**IN THE MATTER OF  
ENVIRONMENTAL ASSESSMENT CERTIFICATE #E14-02  
HELD BY BRITISH COLUMBIA HYDRO AND POWER AUTHORITY**

**FOR THE  
SITE C CLEAN ENERGY PROJECT**

**AMENDMENT #5 (AMENDMENT)  
TO CERTIFICATE #E14-02**

**Figure 4.33 Rev 1**  
**Highway 29 Realignment - Cache Creek Segment**

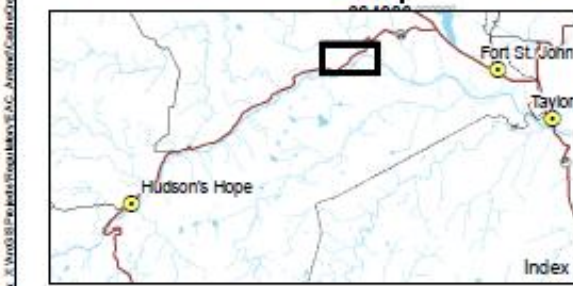
- 1. Segment "Cache Creek" in Table 4.5 in Section 4.3.4.1 of Schedule A (Project Description) is repealed and replaced with:
  - Total Length of Segment (km) "up to 9.0"
  - Causeway Length (m) – "Not applicable"
  - Bridge Length (m) "up to 700"
  - Number of Piers "up to 8"

- Bridge Span “up to 9”
  - Figure Number “4.33 Rev 1 and 4.33 Rev 1 – Detail”
2. “Figure 4.33” in Schedule A is repealed and replaced with “Figure 4.33 Rev 1” and “Figure 4.33 Rev 1 – Detail” (Appendix A of this Amendment).
  3. The Highway 29 realignment for the Cache Creek Segment must be constructed within Corridor 2019 (Amendment #5) and the Holder may utilize Temporary Works (Amendment #5) during alignment construction of the Cache Creek Segment as shown in “Figure 4.33 Rev 1” and “Figure 4.33 Rev 1 – Detail” (Appendix A of this Amendment).
